SAUSALITO-MARIN CITY SANITARY DISTRICT

**ADDENDUM NO. 2**

**Treatment and Wet Weather Flow Upgrade  
(Project No. 0055-006)**

**January 25, 2017**

TREATMENT AND WET WEATHER FLOW UPGRADE		DWG NO <b>E-25</b>
<b>PARTIAL SITE PLAN THICKENER, SEC. DIGESTER &amp; GEN. BLDG.</b>		SHEET NO 191 OF 226
		PROJ NO 055-006
		DATE NOVEMBER 2016

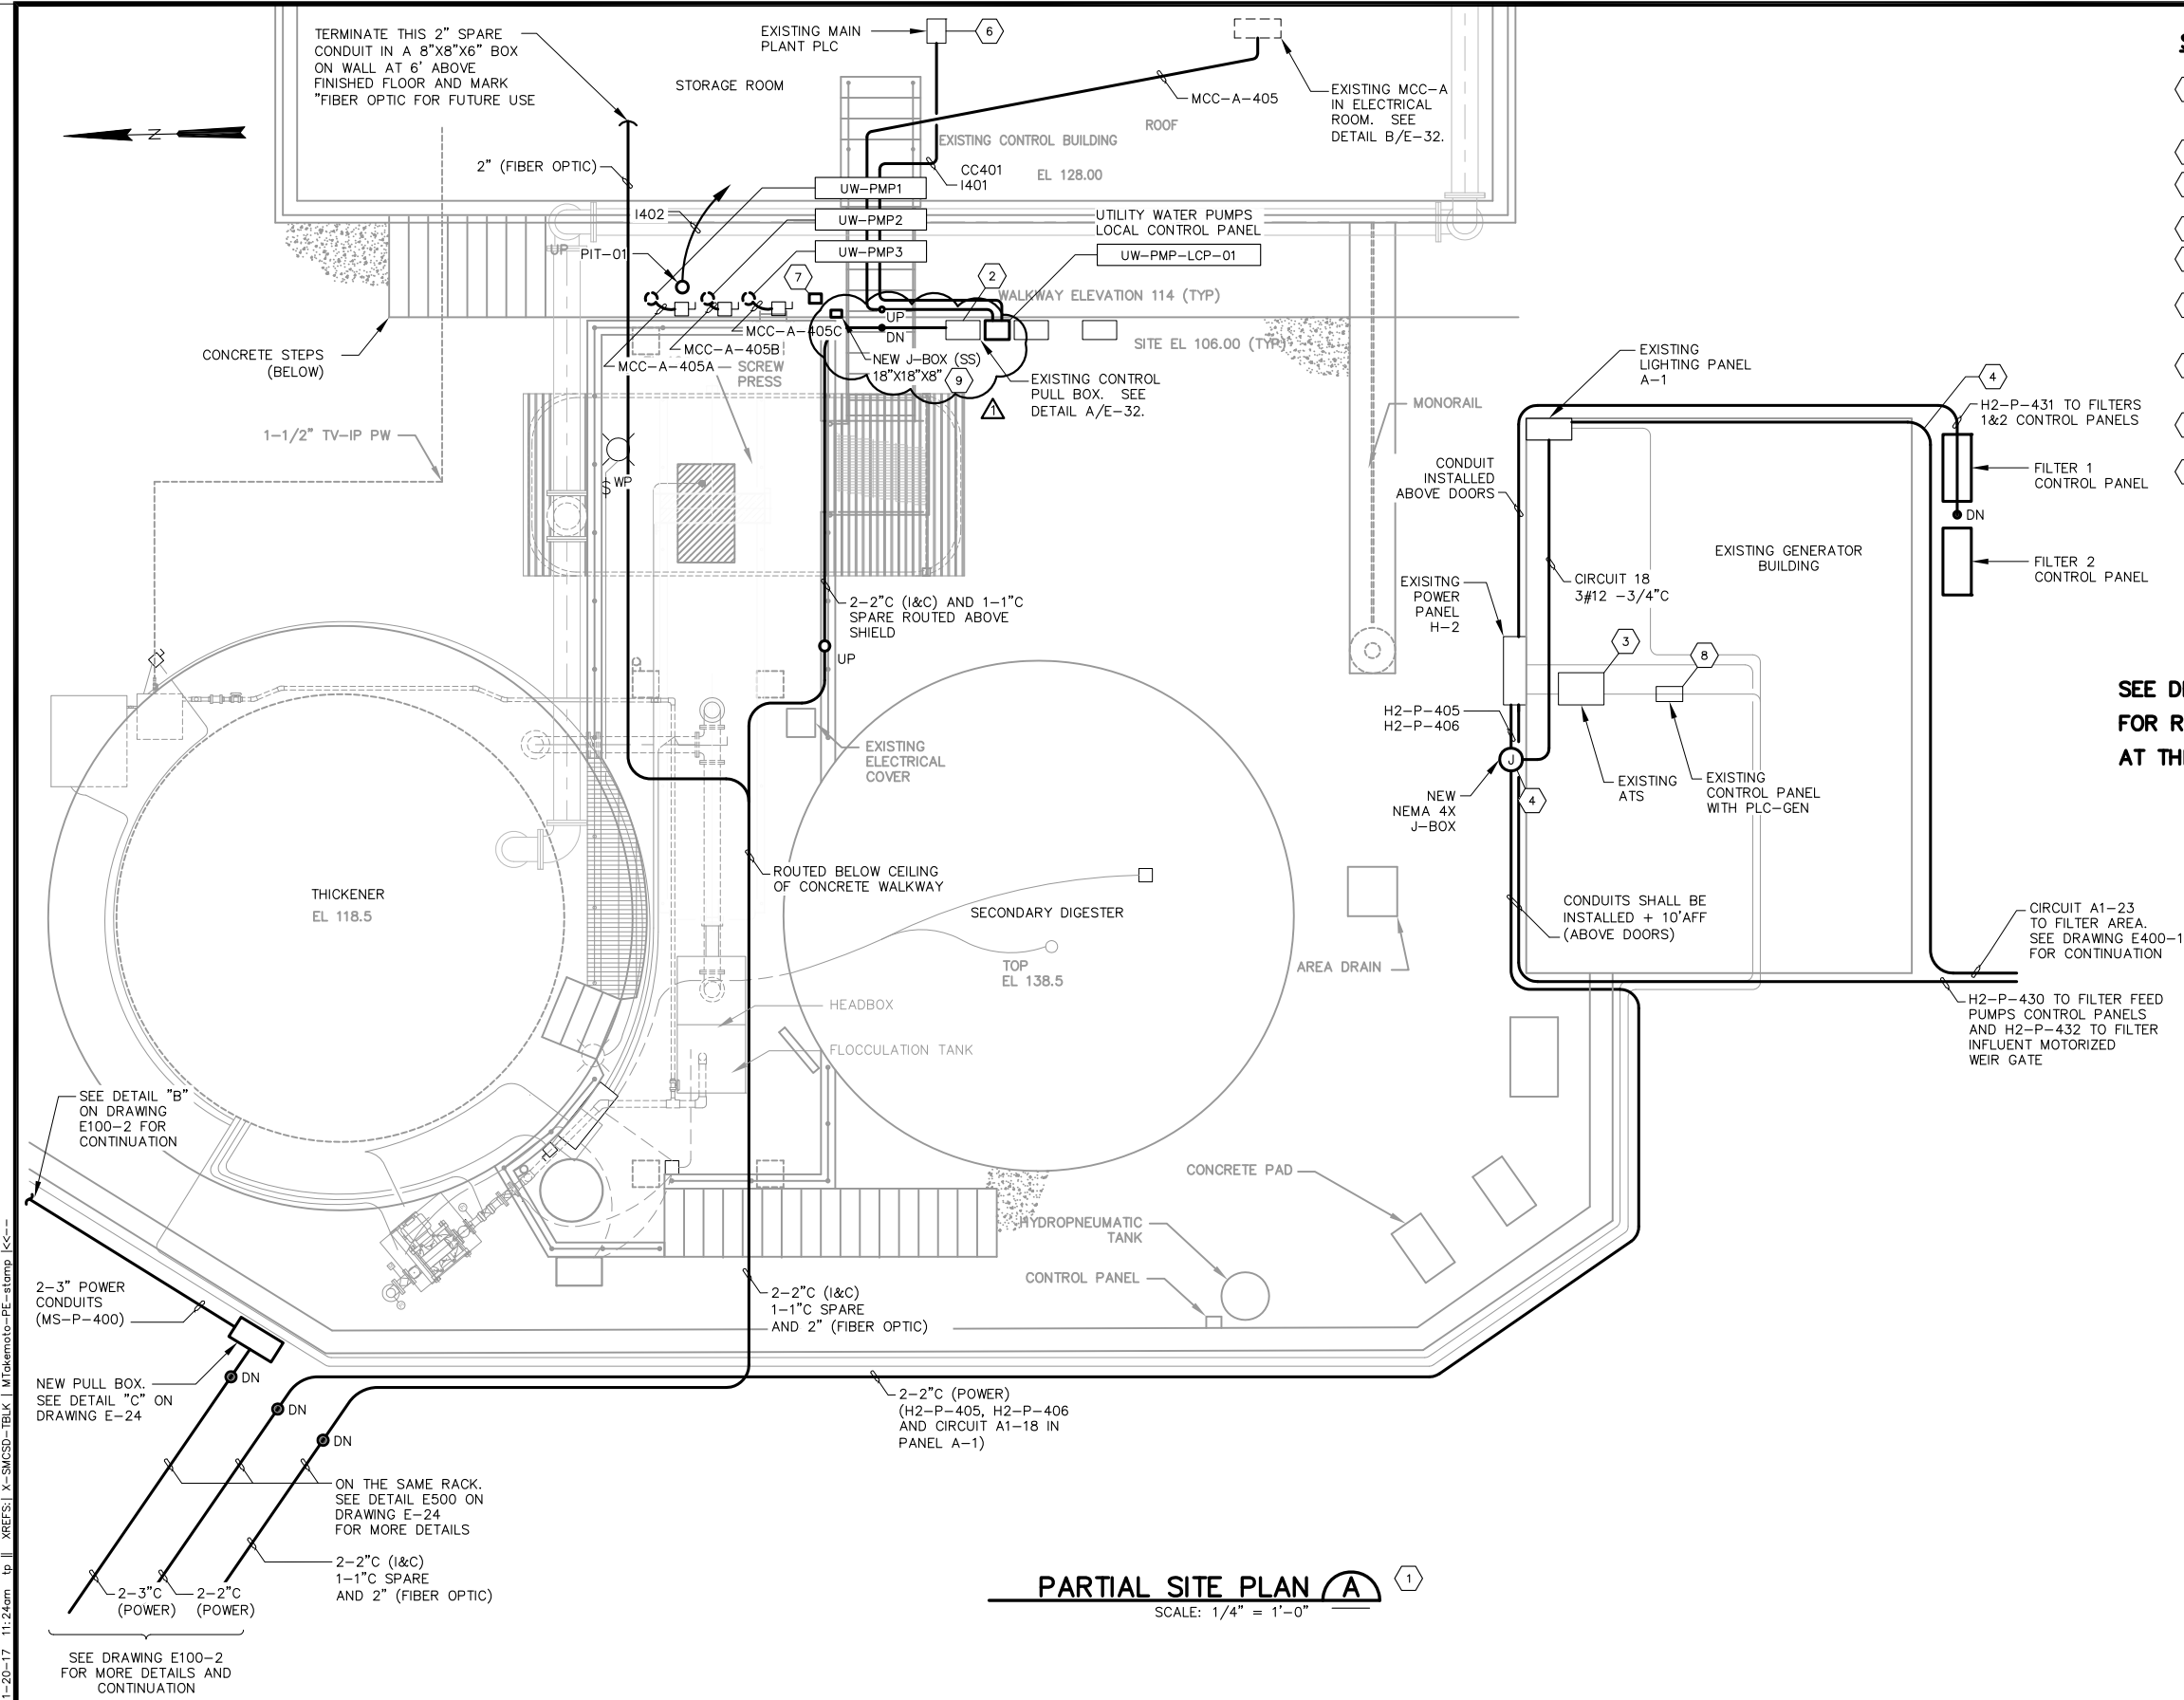
**2.31 Sheet 191, Dwg. No. E-25 PARTIAL SITE PLAN, THICKENER, SEC. DIGESTER & GEN. BLDG.**

**Change:** Delete the sheet in its entirety and replace with version as provided in Attachment 5.
